Response letter of egusphere-2025-4984

Please find the revised version of our manuscript “Technical Note: Benefits of Bayesian estimation of model parameters in a large hydrological model ensemble”, which we would like to resubmit for publication in *HESS*

Response to the comments from Referee #1.

Figure 2. Differences in KGE (a, b) and NSE (c, d) between BPA and deterministically optimized models (boxplots) in 5-year (a, c) and 1-year (b, d) calibration scenarios. Red dots show the performance differences between BMPA and BMA (see Section 3).

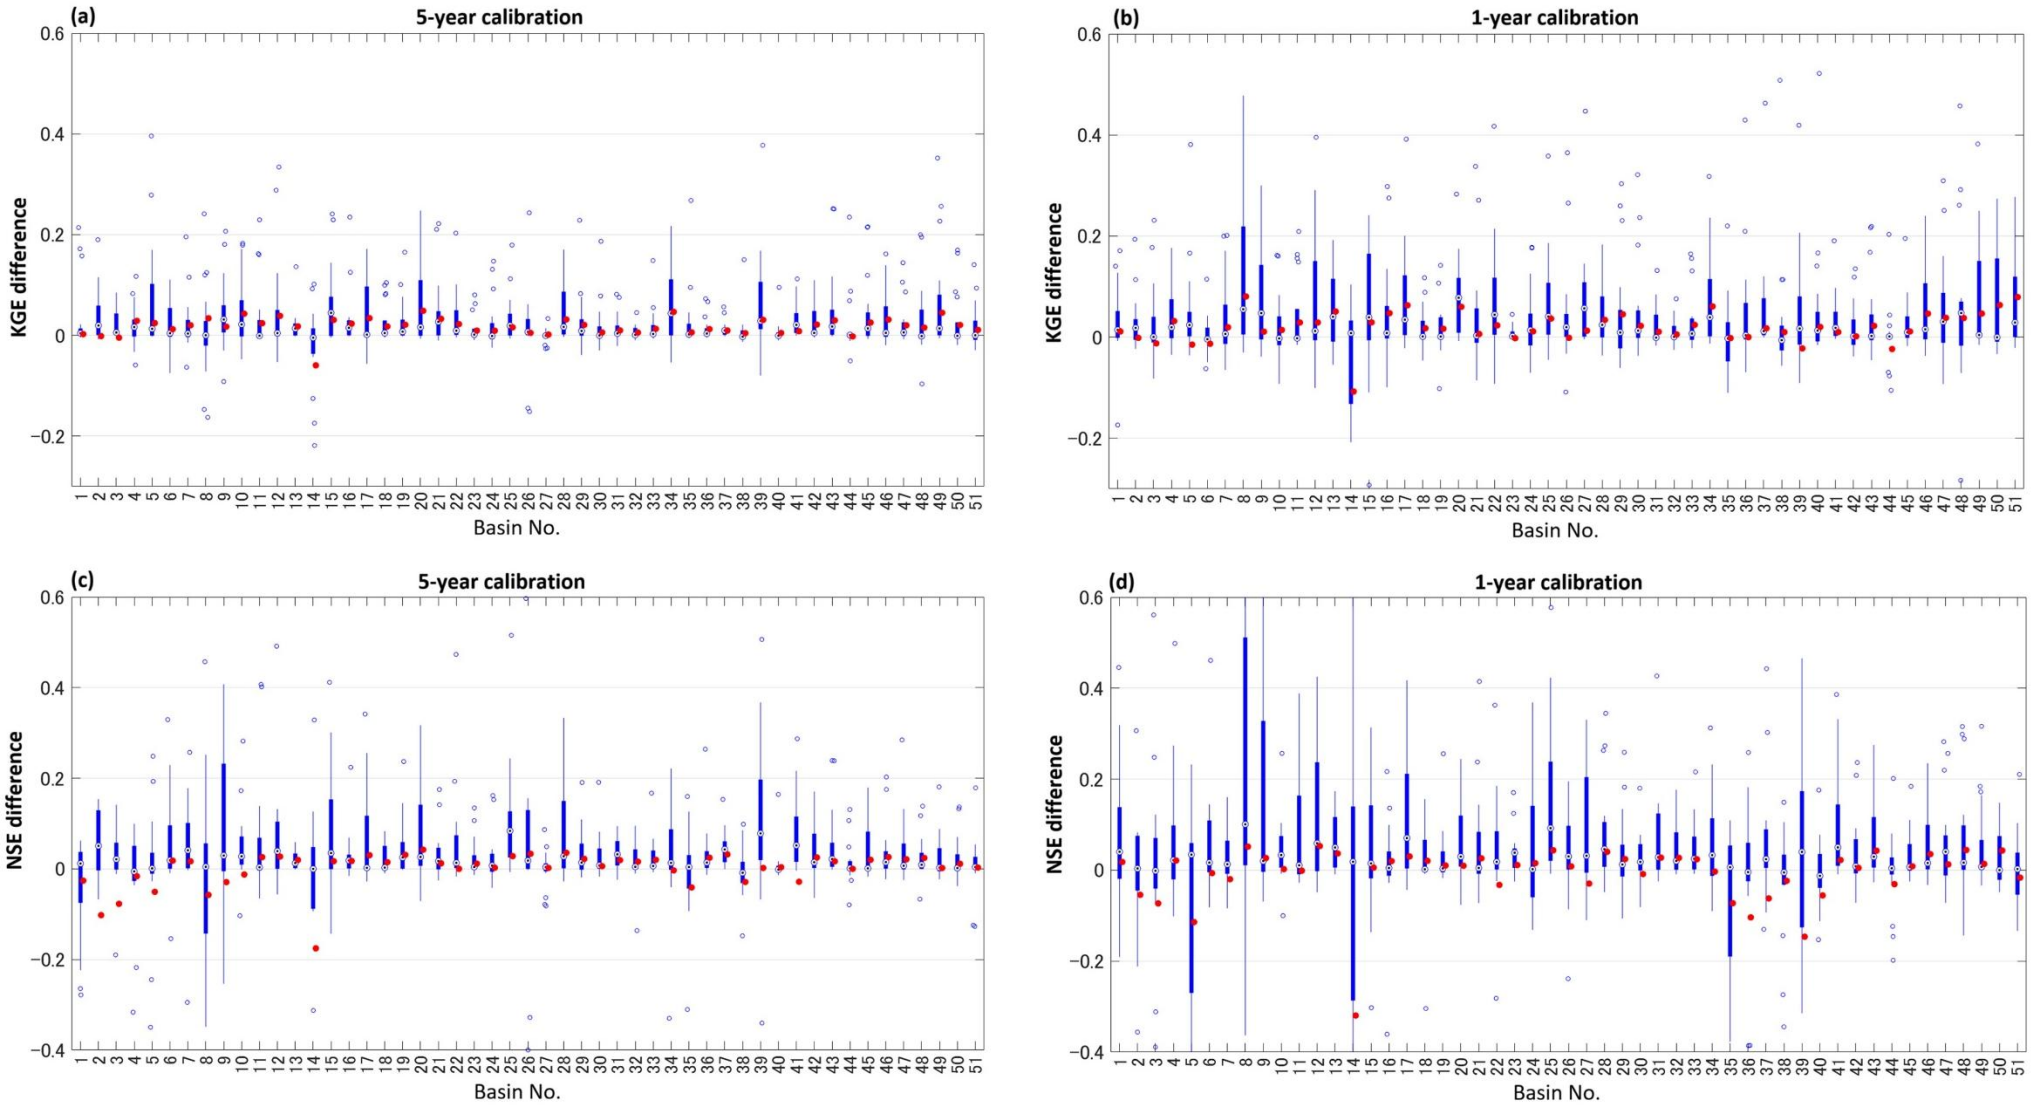
(1.4) Figures: Some figures are too small or cluttered to see the point the authors are making.
Figure 2: The subplots are quite small and it is difficult to see the authors main point (that the BPA surpasses the deterministically optimized models particularly for data-sparse scenarios) due to the clutter within the axes and the broad scales used on the y-axes.
Figure 3: It is not easy to see that more complex models benefit more from BPA partly because many model-basin pairs have near-white squares due to the colormaps. It would also be beneficial to add some indication of whether a model/basin benefits from BPA or not as currently the reader has to count the squares to find this information.
→ Due to a restriction in the submission process of EGUSphere, the resolution and size of the figure is not good in the document which referees received. We believe that the quality of the figure is not problematic when published. We put Figure 2 below for a reference, since we can control what to show in this pdf.

Figure R1. Performance of BPA with the different numbers of samples.

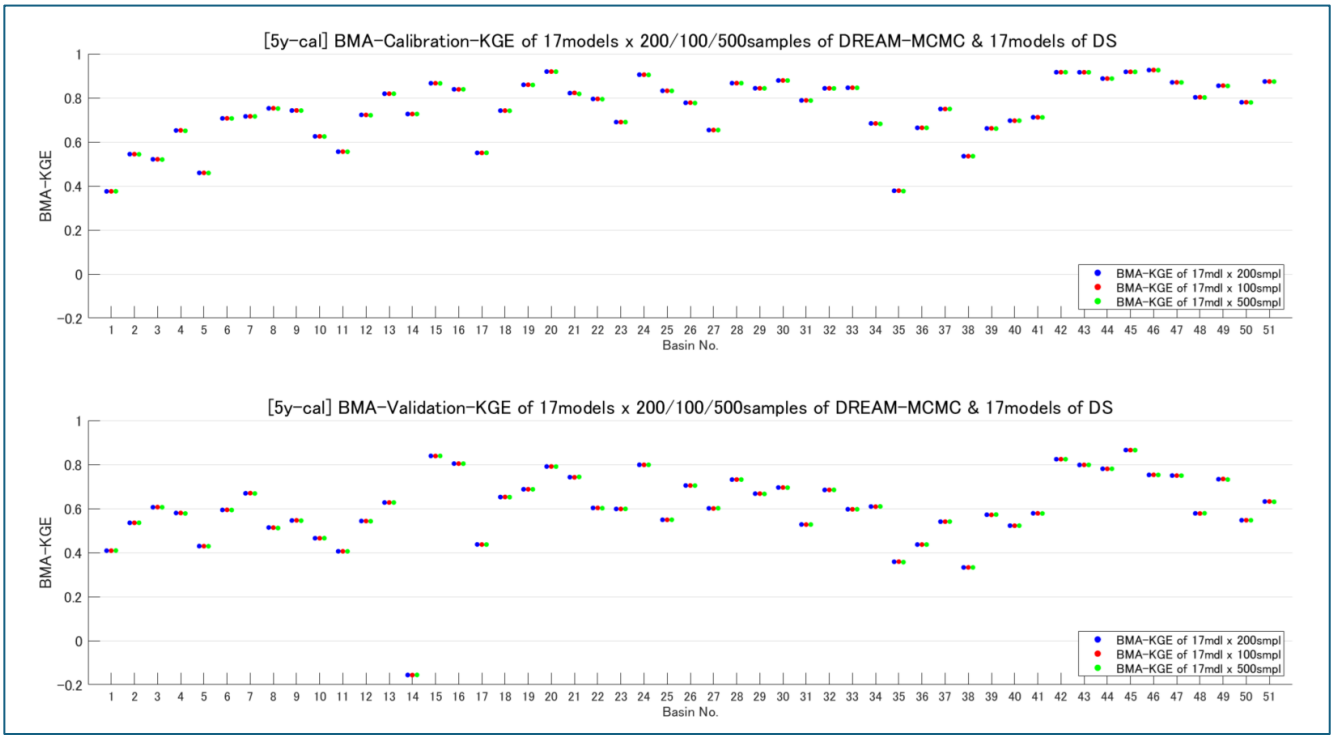
(2.1) 1. Justify and test the posterior sample size (200 draws). You draw 200 parameter sets from the MCMC output to represent the posterior. Please justify this choice (e.g., computational budget vs diminishing returns) and add a brief sensitivity check (e.g., 100 vs 200 vs 500
draws for a subset of basins/models) to demonstrate stability.

→ Figure R1 shows the performance of BPA sampled from the different numbers (100, 200, and 500) of parameters in the calibration period. We could not find any significant differences and concluded that 200 parameter sets are already enough to represent the posterior. We have briefly mentioned this result in the revised version of the paper:

Lines 184-185: The performance is insensitive to the number of the sampled parameters if it is larger than 100 (not shown).
